ADDENDUM NO. 1

TO: PLANS AND SPECIFICATIONS FOR STATE OF MISSOURI

Remodel Space for Printshop Utilization
Scruggs Station Warehouse
Jefferson City, Missouri
PROJECT No.: O2544-01

E101

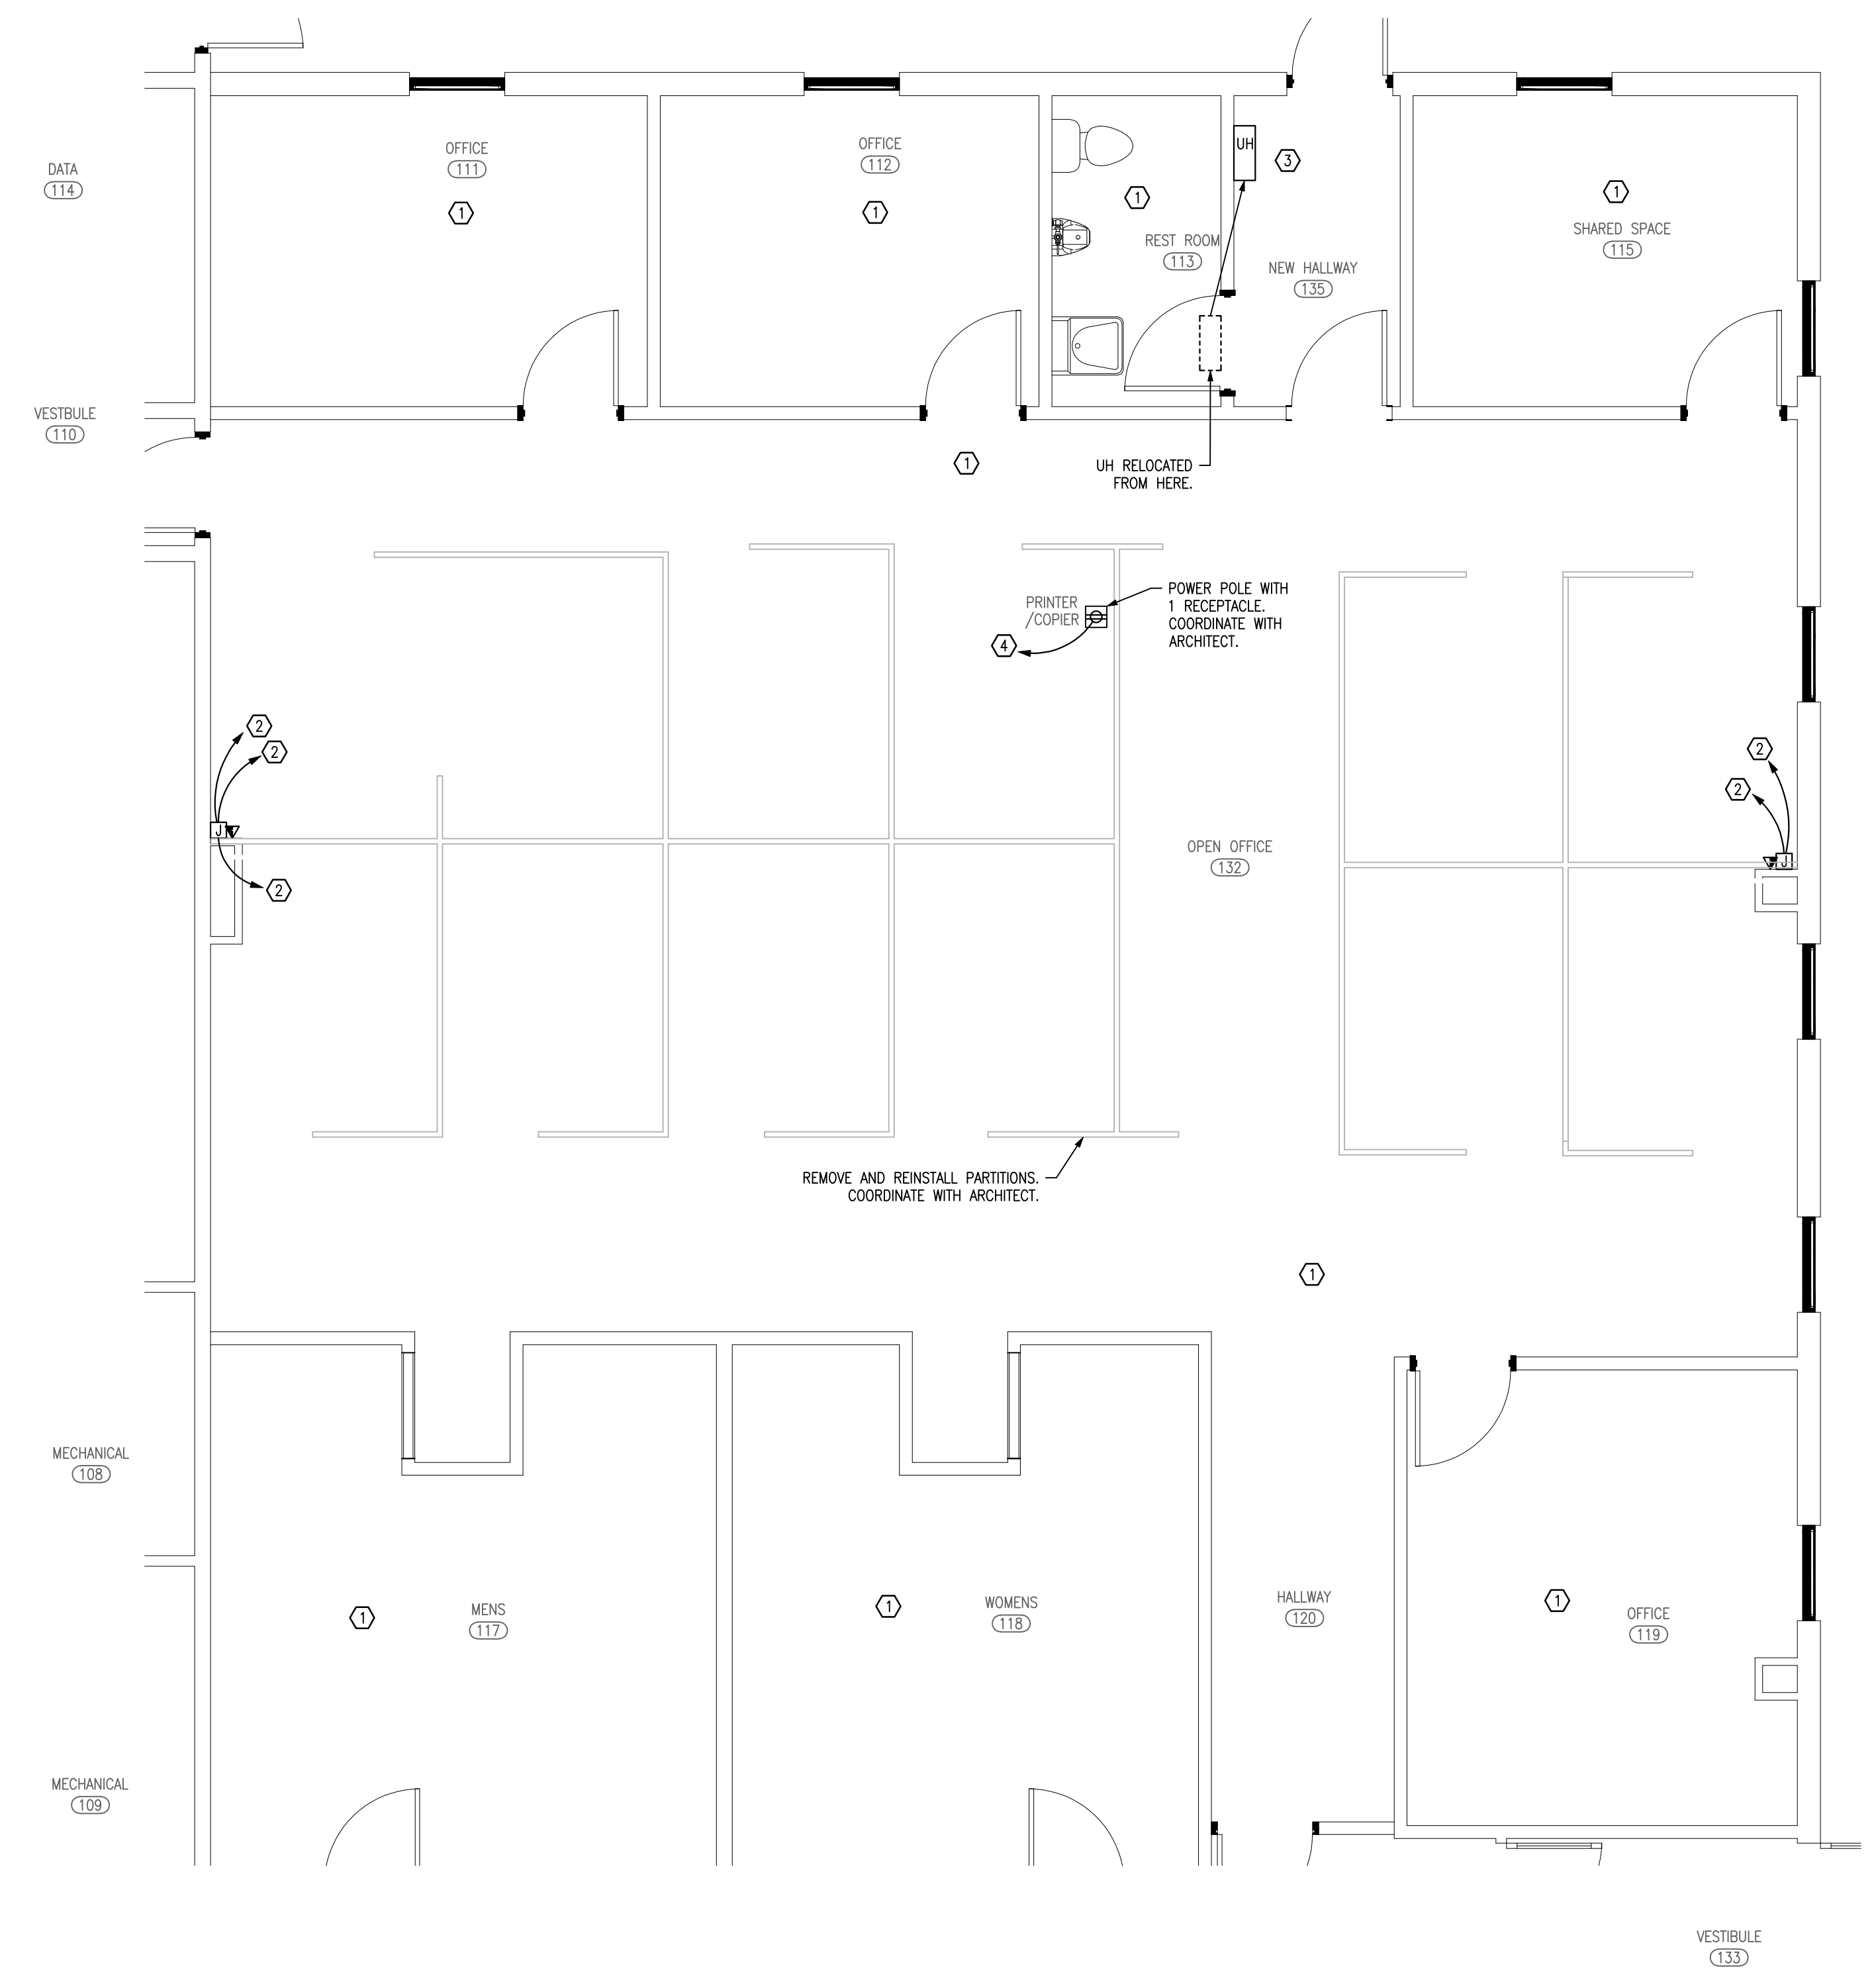
8. **Sheet M103:** (full sheet re-issued)
 - a. Updated architectural background
9. **Sheet E101:** (full sheet re-issued)
 - a. Updated architectural background

E102

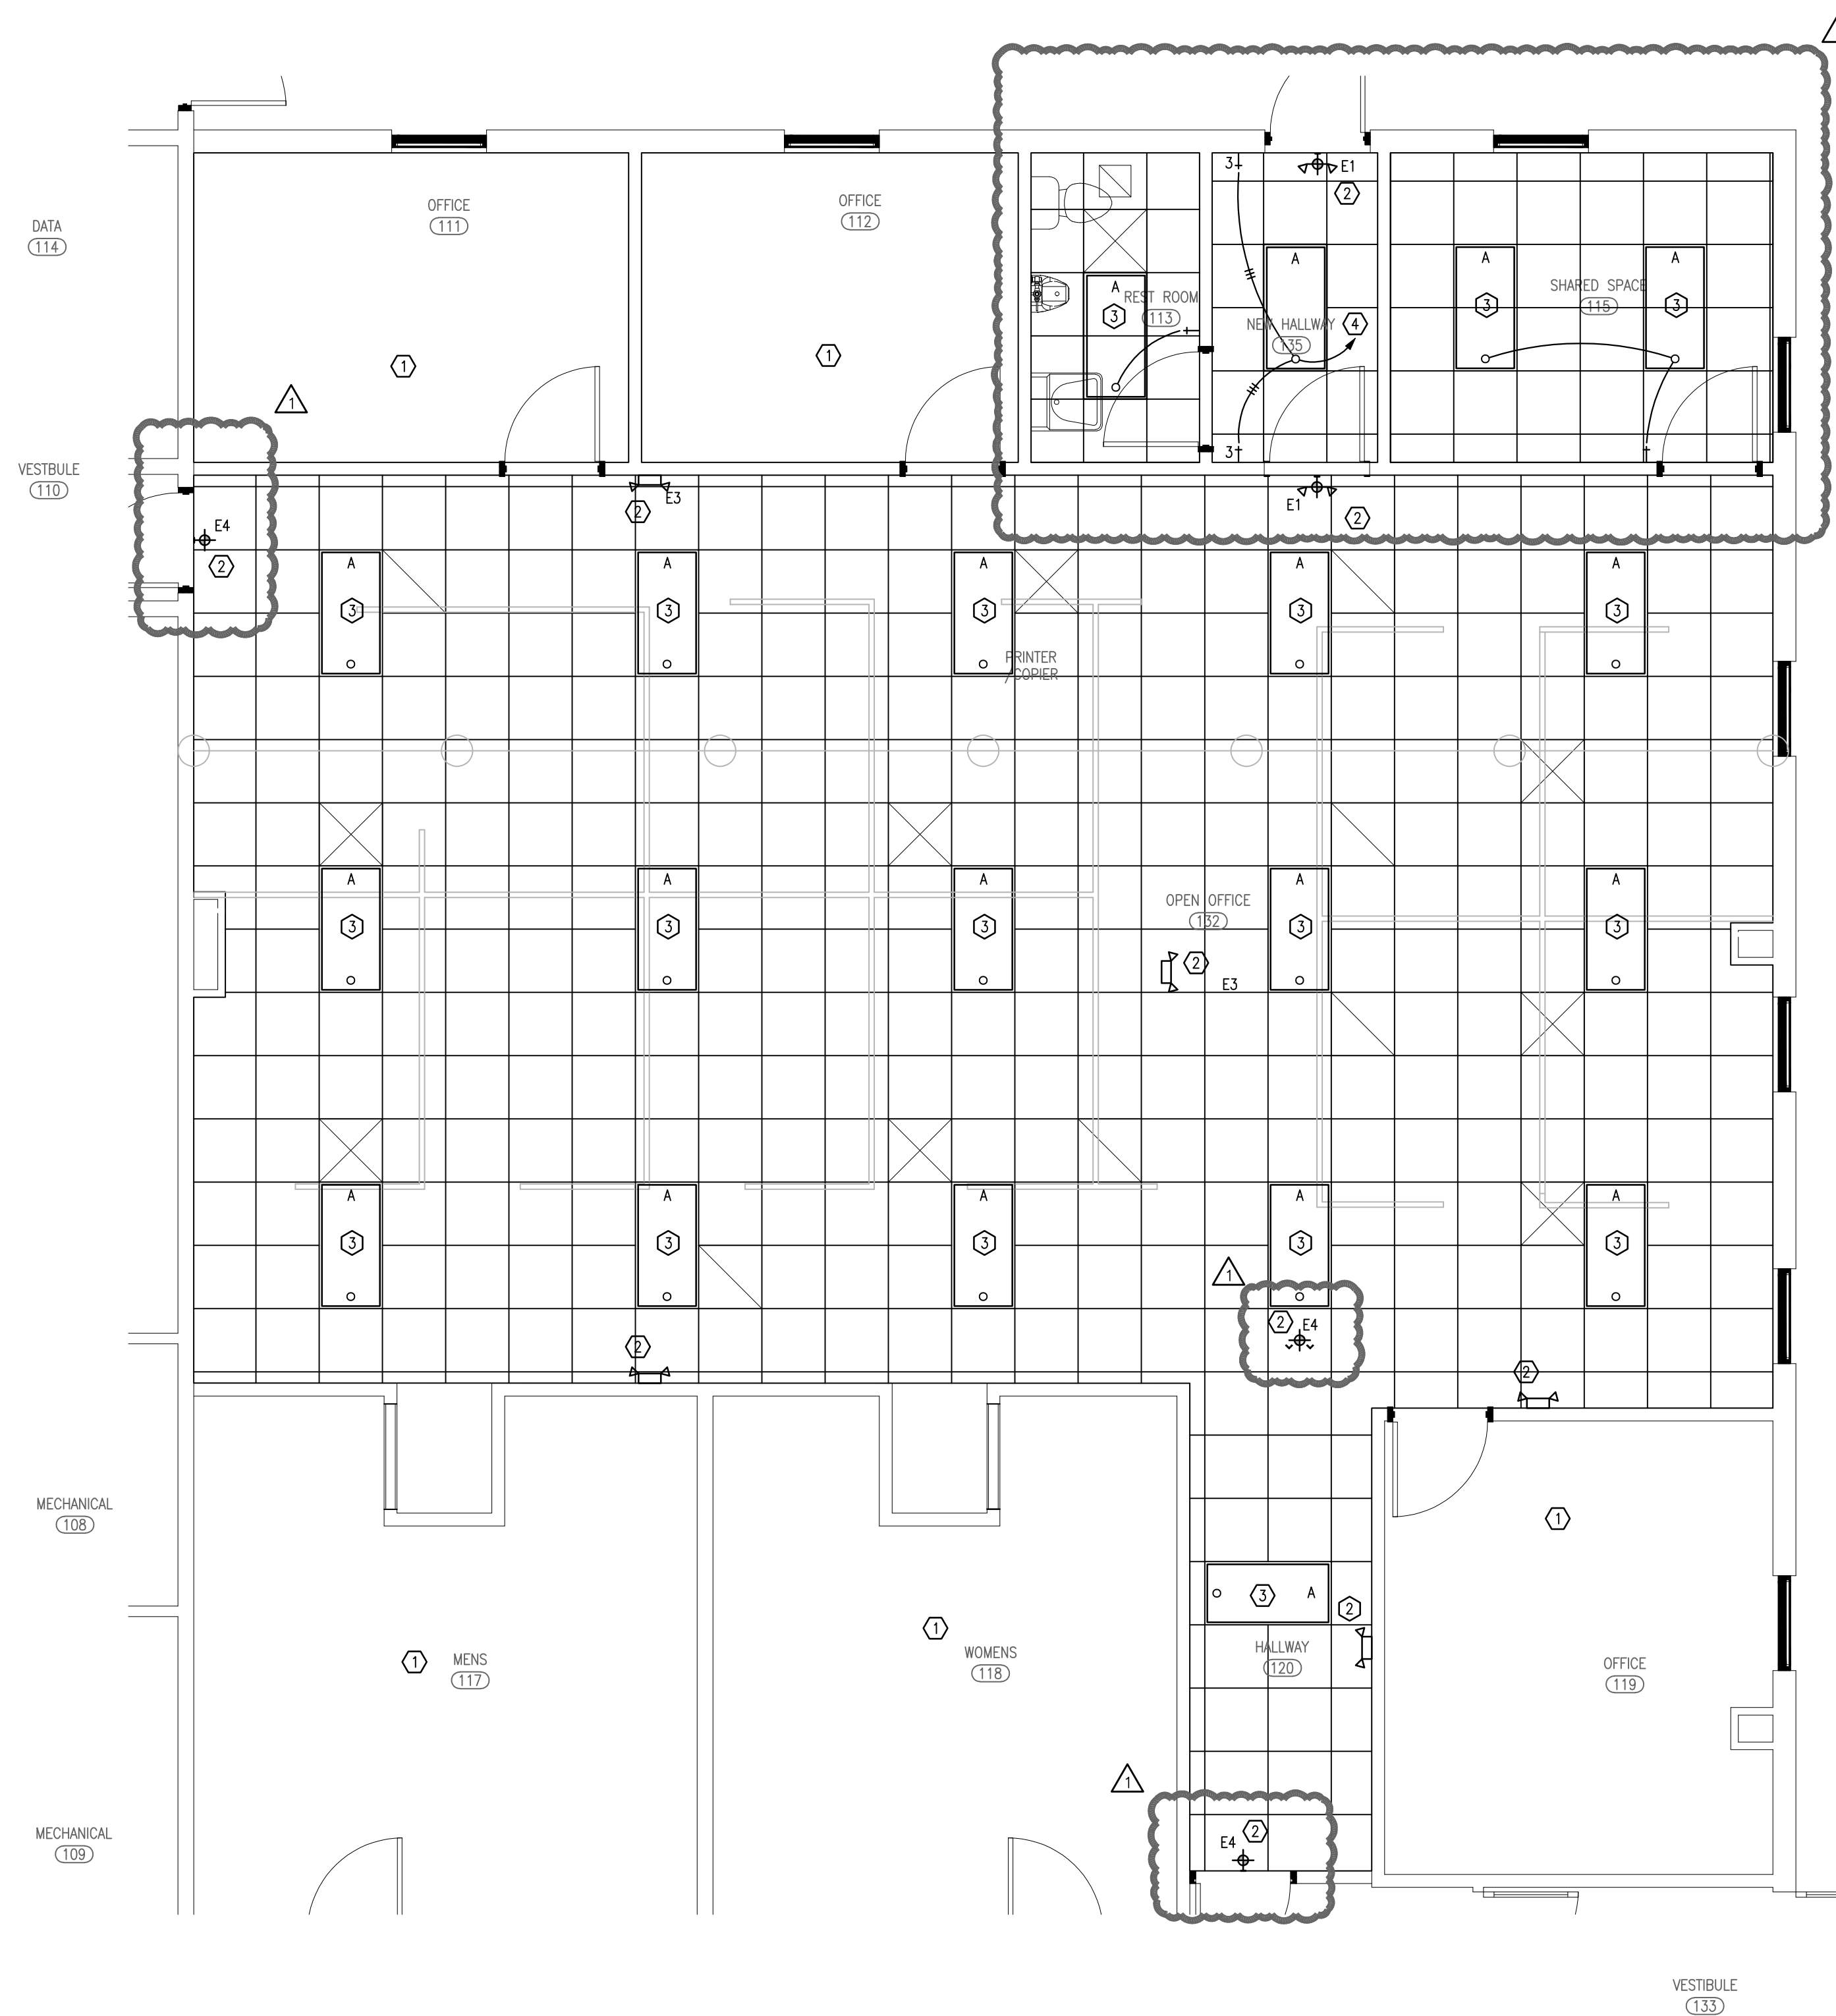
- a. Add new light fixtures to Restroom 9-03, Hallway 9-04, and Office 9-05.

E103
SHEET 27 OF 28

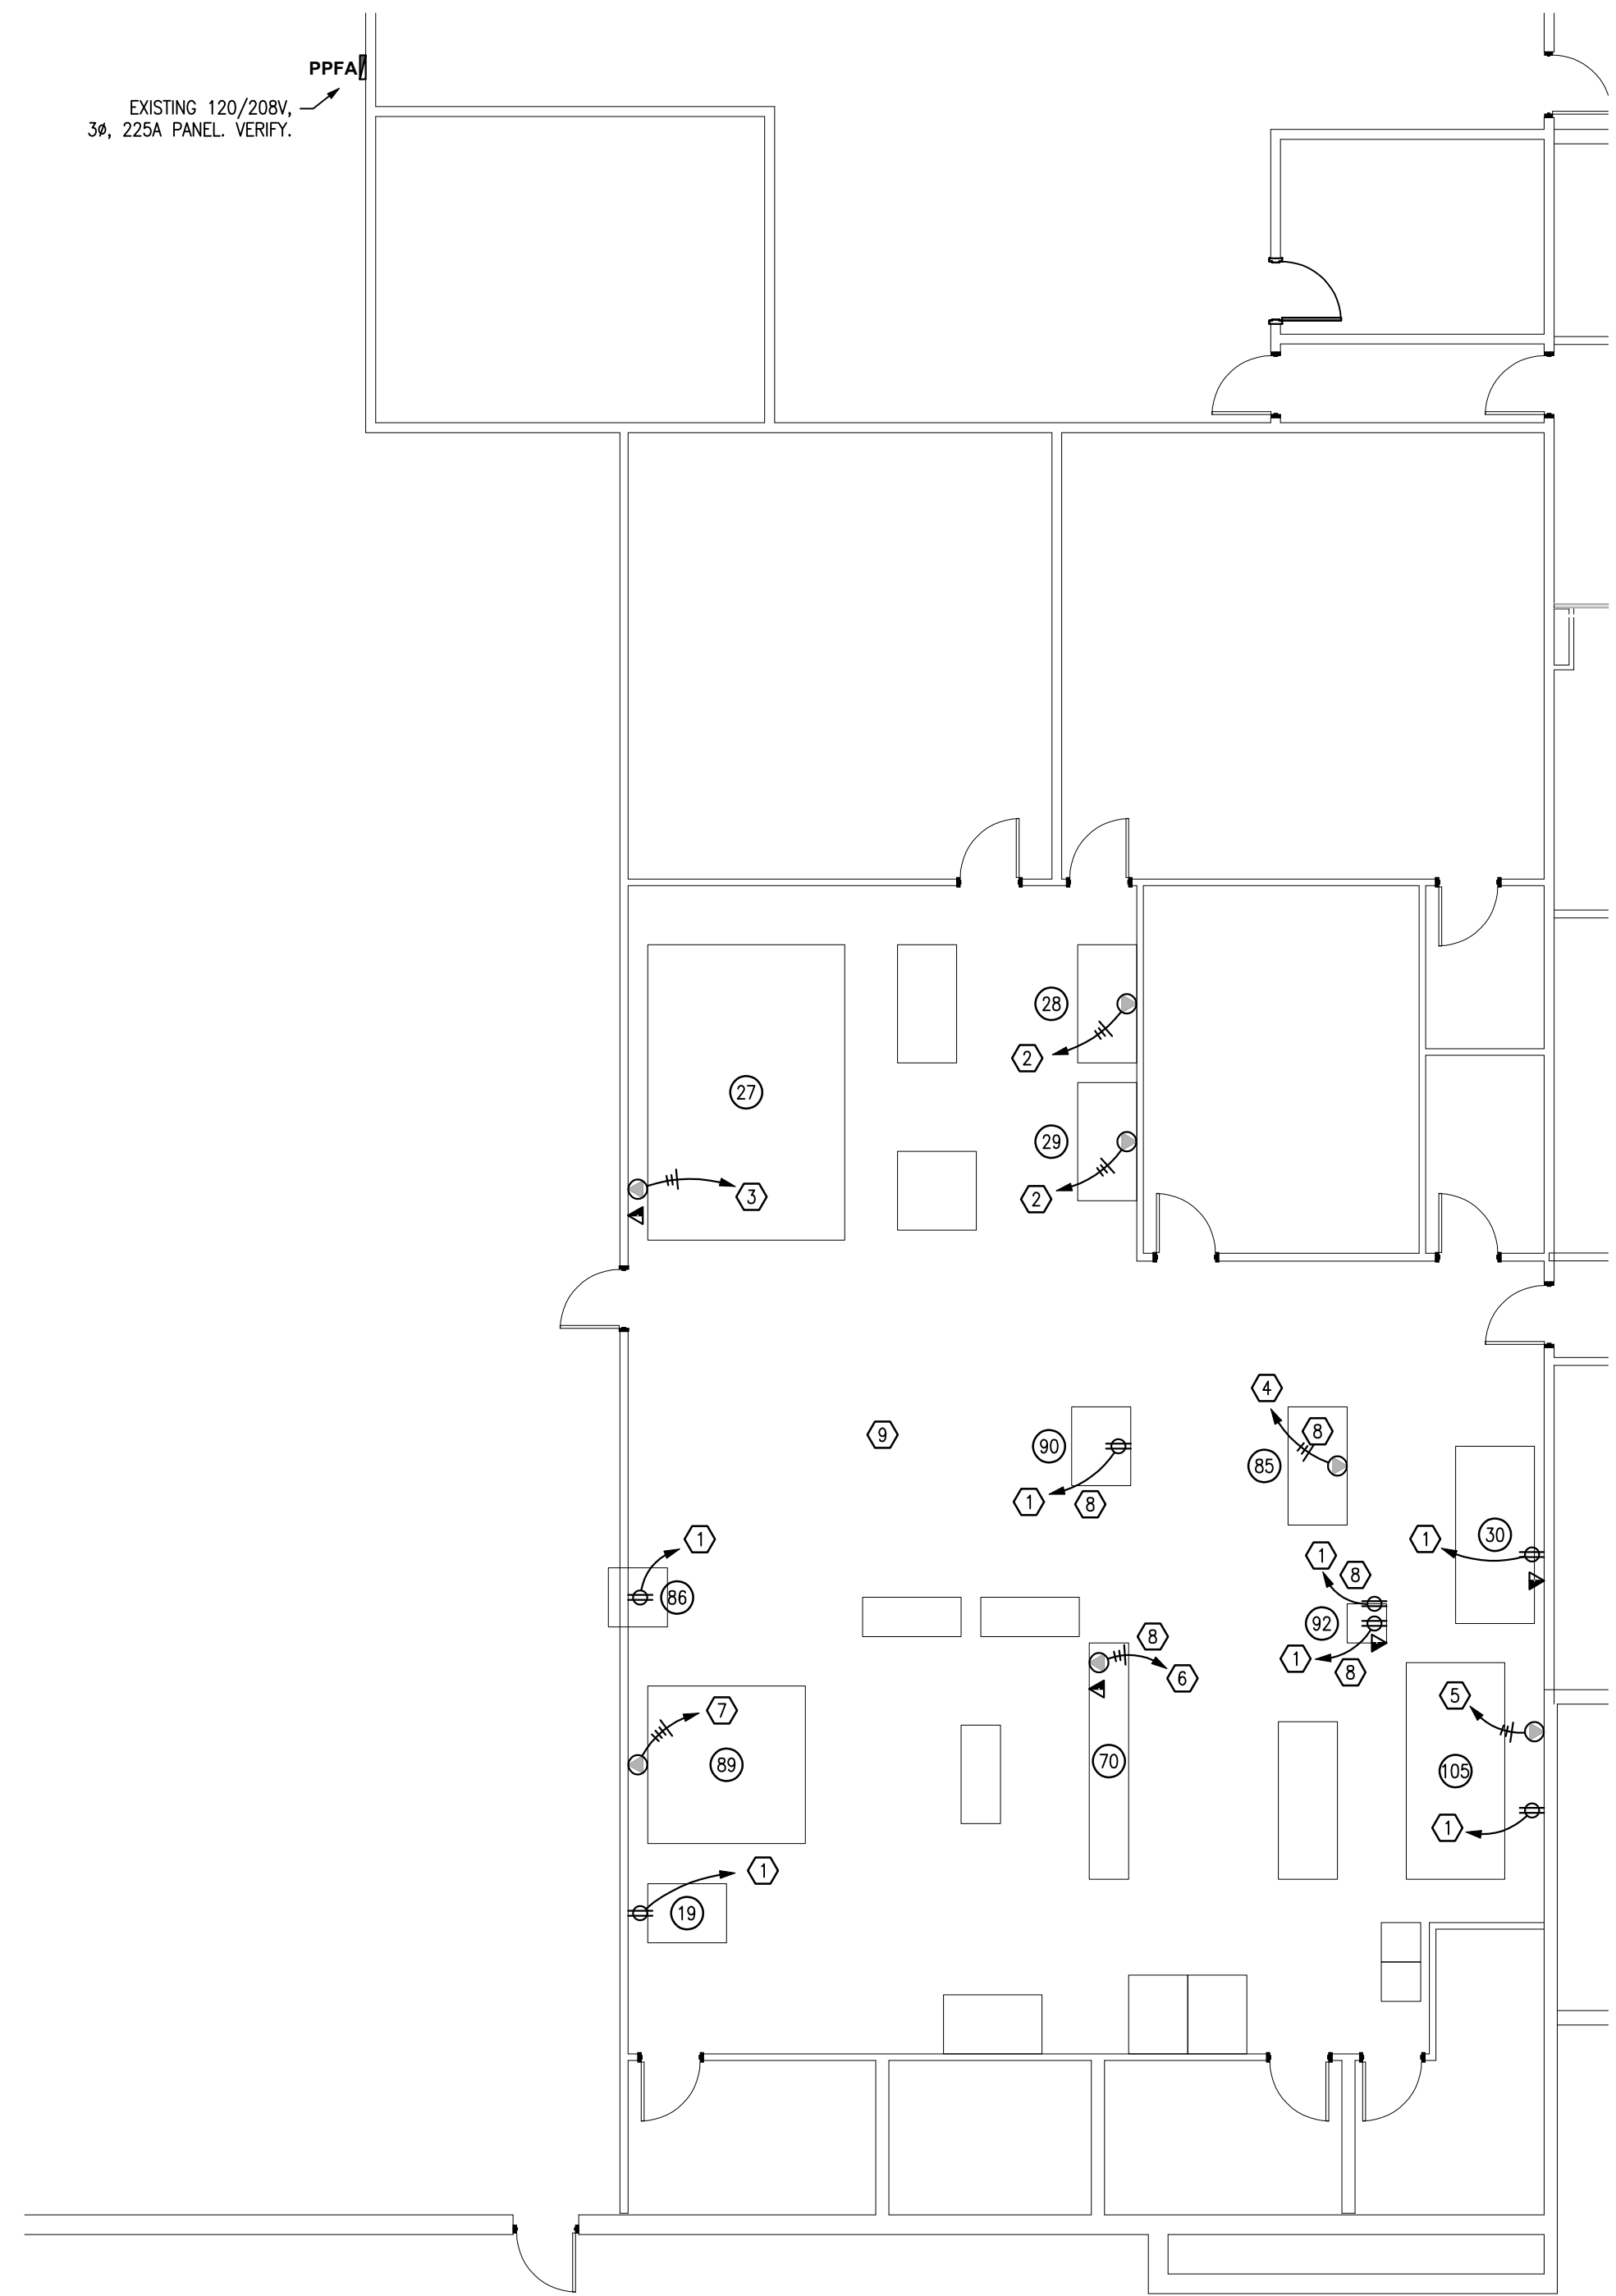
Updated architectural background.
